September 23, 2009
Matt Brown, Applied Micro
IEEE 802.3az Interim Meeting

Edits to Clause 49 to replace scrambler reset with scrambler bypass.

This is necessary to resolve Comment #223.

Figure 49-5—Scrambler

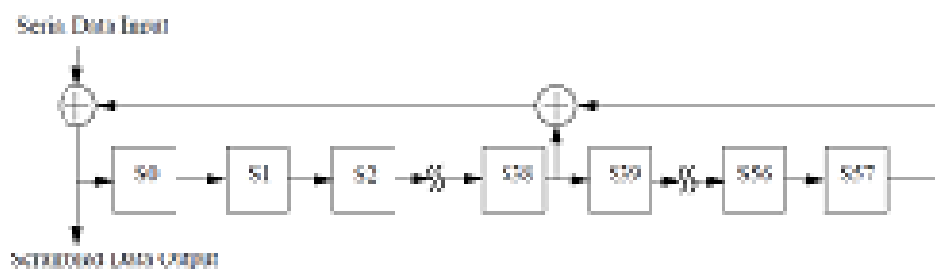
In figure 49-5, show bypass mux at output of scrambler.

Currents scrambler diagram
